Struthers Ranch Filing 4 Lot Nos. 1 & 2
Traffic Impact Study
(LSC #204111)
November 18, 2022

LSC #204110
PCD File No. PPR-2248

RE: Struthers Ranch Filing 4 Lot Nos. 1 & 2
Traffic Impact Study
El Paso County, Colorado
EPC PCD File No. PPR-2248
LSC #204110

Exhibit 1
Intersection Sight Distance
(Struthers Ranch Rd to the South)

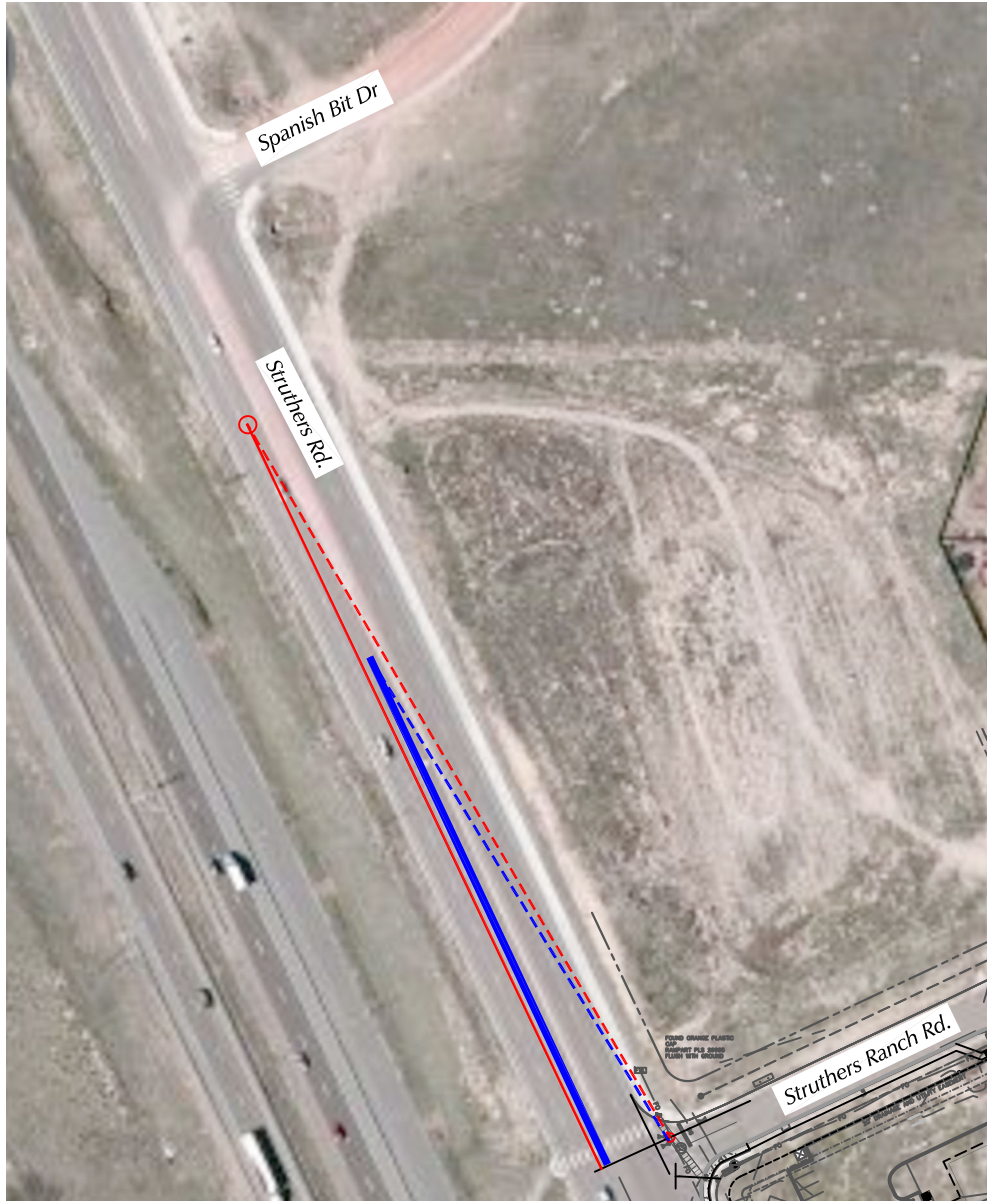
Provide line of sight for single unit truck.
